## **ADDENDUM NO. 1**

**DATE: May 23, 2015**  
**FROM: City of Grand Junction Purchasing Division**  
**TO: All Offerors**  
**RE: Engineering Study for City of Grand Junction Water Treatment Plant Upgrade Project RFP-4604-19-DH**

**HYDRAULIC PROFILE**

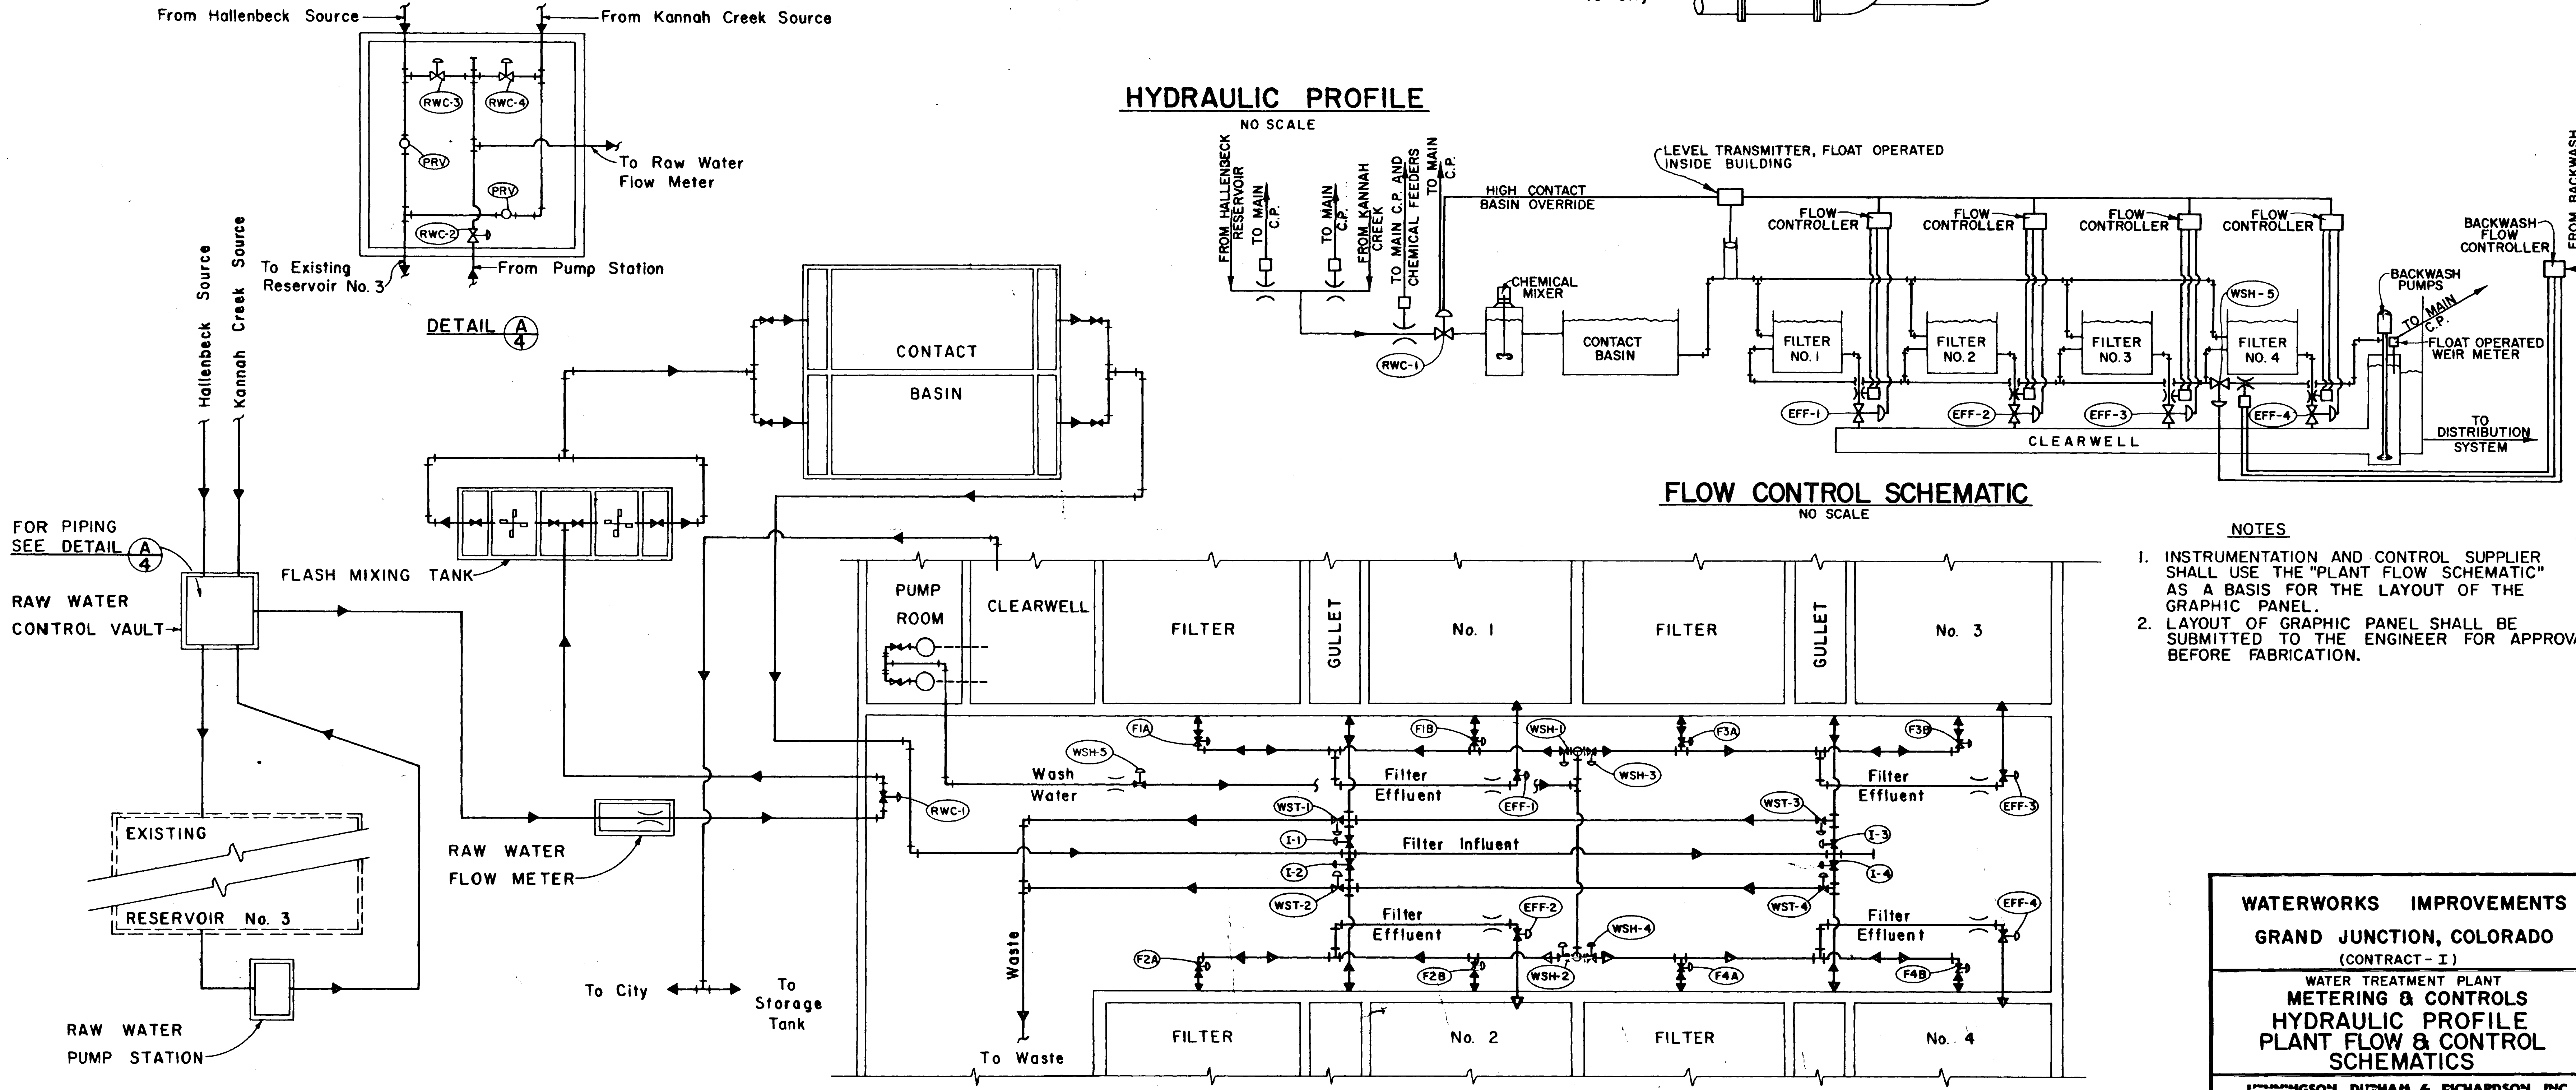
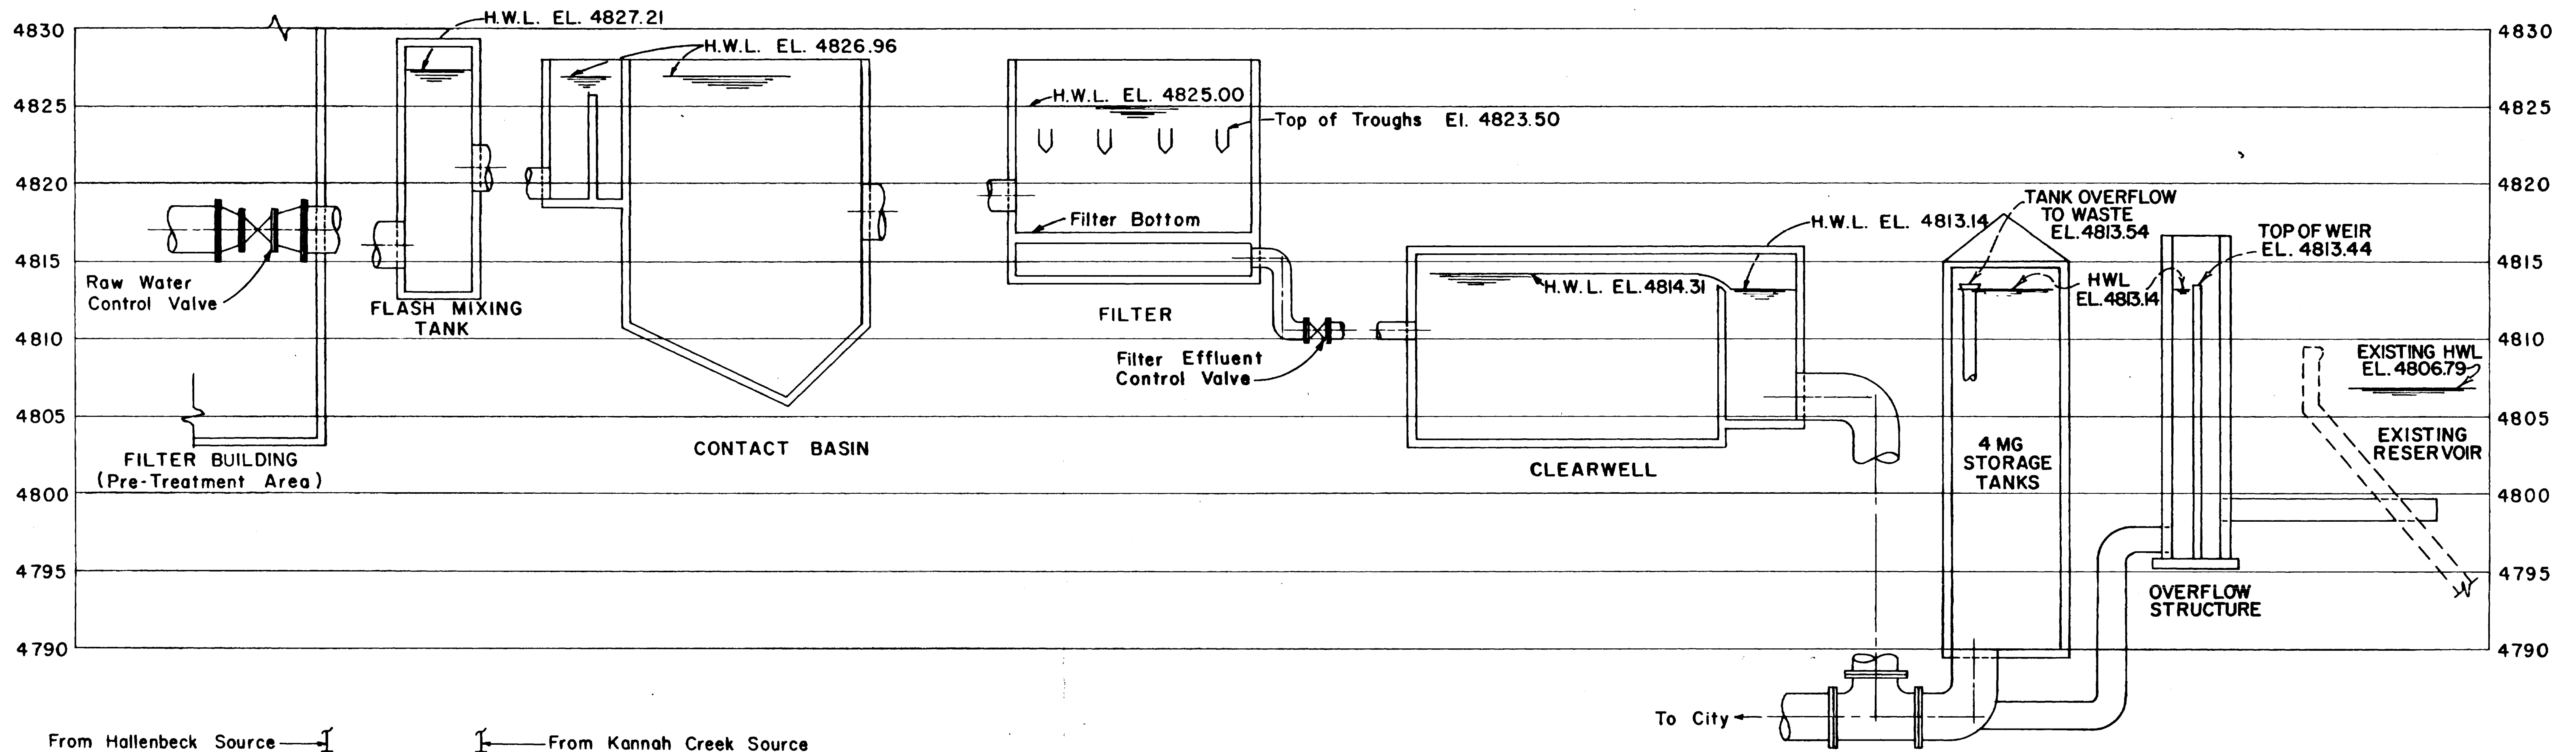
4. Q. Can the City please provide the as-built drawings, or at a minimum, the hydraulic profile of the Orchard Mesa WTP?

A. See attached as built drawings.
